## COUNCIL ASSESSMENT REPORT

<b>Panel Reference</b>	PPSSNH-214
<b>DA Number</b>	MOD0070/21
<b>LGA</b>	Ku-ring-gai
<b>Proposed Development</b>	Modification to DA0307/17 proposing mesh security fencing and racking
<b>Street Address</b>	950 Pacific Highway and 2 Bridge Street, Pymble
<b>Applicant/Owner</b>	Bunnings Properties Pty Ltd
<b>Owner</b>	Potpura Pty Ltd
<b>Date of DA Lodgement</b>	29 April 2021
<b>Number of Submissions</b>	Nil
<b>Recommendation</b>	Approval, subject to conditions
<b>Regional Development Criteria (Schedule 7 of the SEPP (State and Regional Development) 2011)</b>	A section 4.55(2) application that relates to a development consent for Regionally Significant Development that was granted by the SNPP and which seeks to make amendments to conditions of consent that were added by the SNPP and were not included in the council assessment report
<b>List of all relevant s4.15(1)(a) matters</b>	<ul style="list-style-type: none"> <li>• SEPP 55 – Remediation of Land</li> <li>• Draft Remediation of Land SEPP</li> <li>• Ku-ring-gai Local Environmental Plan 2015</li> <li>• Ku-ring-gai Development Control Plan</li> <li>• Ku-ring-gai Development Contributions Plan</li> </ul>

**Figure 2** – extract from proposed section plan showing mesh fencing and racking in the bagged goods area

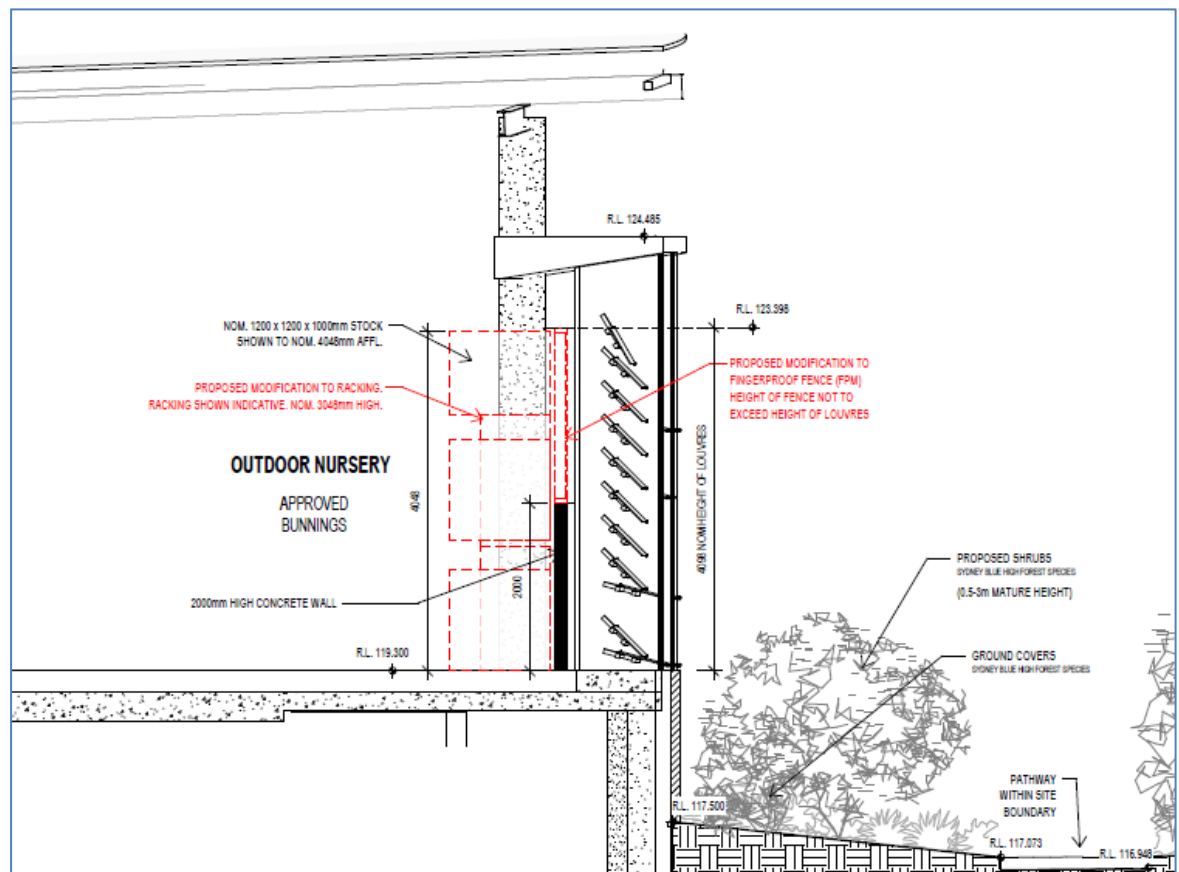
The proposed modification involves the installation of finger-proof mesh and racking above the level of the low sandstone clad base wall to the colonnade at the north-eastern side of the nursery area and above the 2m high concrete wall at the north eastern side of the bagged goods area. The proposed 4.09m high mesh fencing and racking runs for the full length of the north eastern side of the bagged goods and nursery area and has an overall length of 84.4 metres.

The proposed installation of racking along the Pacific Highway frontage, in addition to the mesh fencing and coloured glass louvre screen, will result in a semi solid wall and detract from the quality of the built form. While the racking itself may not be highly visible from the Pacific Highway, the storage of goods on the racking will have silhouette effect and preclude the play of light and architectural expression of the building. The applicant has cited the provision of landscaping within the within the north eastern (Pacific Highway frontage) setback as justification for the proposed modification. It is not agreed that the proposed landscaping is intended to or is likely to have the effect of a solid screen or hedge and block views of the building from Pacific Highway. The approved design outcome is one of a coloured glass louvres and concrete blade walls visible through landscaping within the street setback zone. The modification fails to contribute to the safety of the public domain and is contrary to the controls and objectives of the KDCP.

Part 9C.9 Corner Building Articulation, Control 3 of KDCP states, *buildings in landmark positions are to be of a high architectural quality and contribute significantly to the local built environment.* Pacific Highway and Ryde Road are busy roads with tens of thousands of vehicle movements per day. Located at the corner of Pacific Highway and Ryde Road as a landmark building, the subject development is highly visible from the many angles. It is important for this landmark building to be of a high quality visual architectural element and to provide an appropriate street presentation to the Pacific Highway and Ryde Road intersection. As discussed above, the introduction of product racking behind the glass louvre screen and colonnade will discourage the play of light and creates a solid wall to the building façade at the Pacific Highway frontage. Further, it does not enhance the safety and surveillance of the public domain. The racking detracts from the design of the building façade and does not achieve a building of 'landmark' quality, which is contrary to the objectives of the KDCP.

The proposed racking is to be deleted as marked on Drawing SK-17A, Revision C, dated 01.03.21 and prepared by Michael Carr Architect.

**Figure 4** – plan showing the location of the mesh fencing and racking in relation to the louvres and blade columns

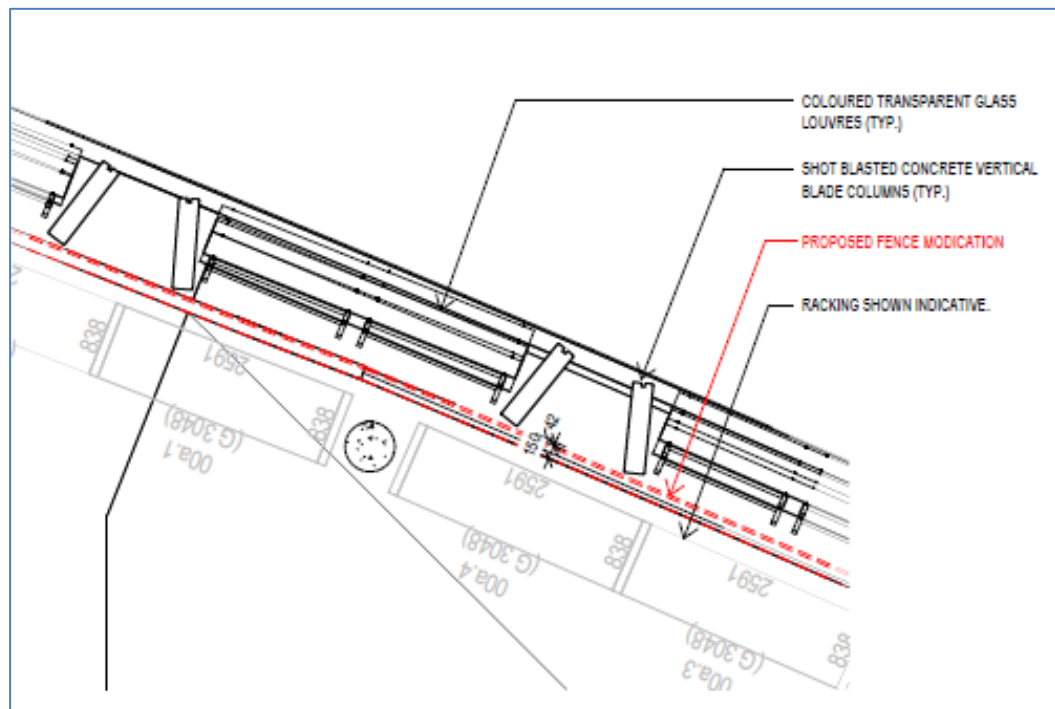
The proposed finger-proof mesh behind the louvre screen and concrete blade columns is considered acceptable as passive surveillance is maintained through the mesh fencing when viewed from the openings between the blade columns. There are 17 openings along the Pacific Highway frontage which is equivalent to 14.5% of the surface area of the building facade. The proposed mesh fencing will retain views into and out of the building and will facilitate causal surveillance, as such, it will satisfy the objective that the building facade design should contribute to the safety of the public domain. The mesh fencing will continue to allow the play of light through the glass louvre screen, whether it is daylight or artificial light, during night trading hours (approved hours of operation include Monday to Friday till 10pm; and Saturday, Sunday and Public Holiday till 7pm), and will achieve the KDCP objective, which is to integrate building elements into the overall building form and façade design.

The finished ground level of the nursery and bagged good areas is 1.8 metres above the finished external ground level. A 2 metres high concrete wall is situated at the north eastern side of the bagged good area, however the gaps between the concrete blade columns are 720mm wide and are potential entry points into the building. The proposed semi-transparent mesh fencing complies with the DCP requirement that security devices be located internally. The mesh will enhance security whilst maintaining for casual surveillance of the public domain

- ~~No wire fencing or panels shall be provided in addition to the louvre screen to the colonnade~~
- The finger-proof mesh fencing shall not exceed the height of the louvre screen at the north eastern side of the bagged good area and nursery.

**Figure 6** – extract from approved DA plan showing details of the colonnade and louvres

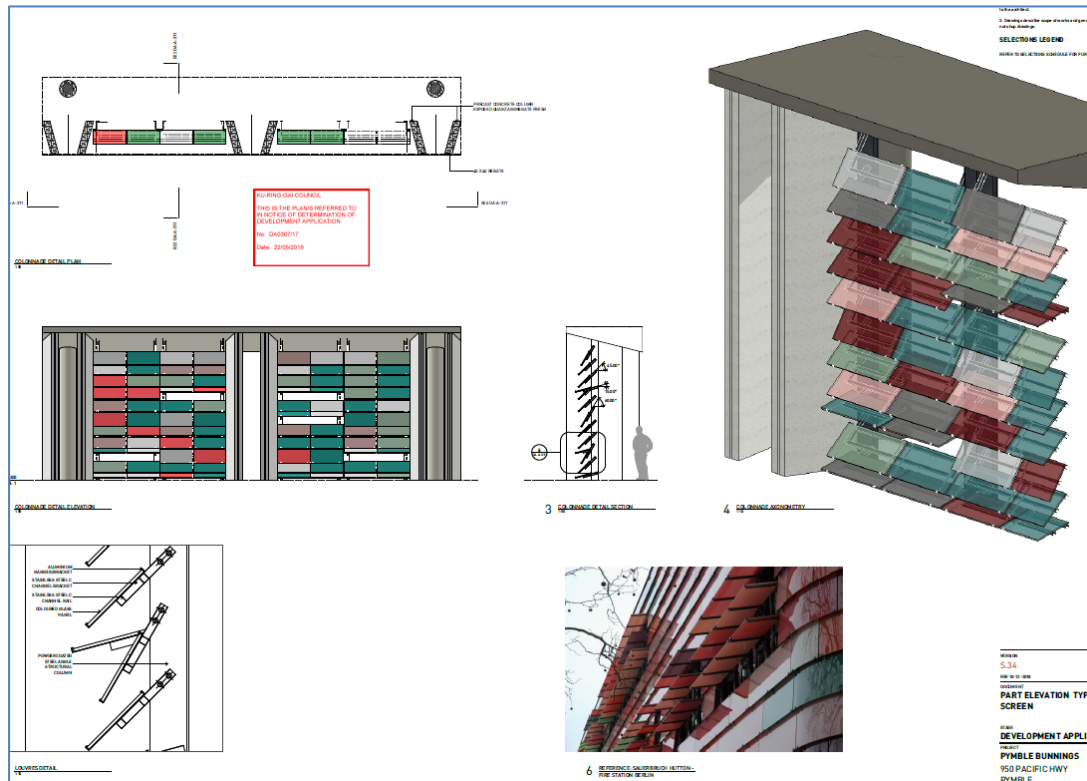
penetrate through the louvre screen and concrete blade wall so that the building facade does not read as a solid wall. This is to ensure that the approved design and materials satisfy the approved building's "landmark" status as required under the Part 9C.9 Corner Building Articulation of KDCP.
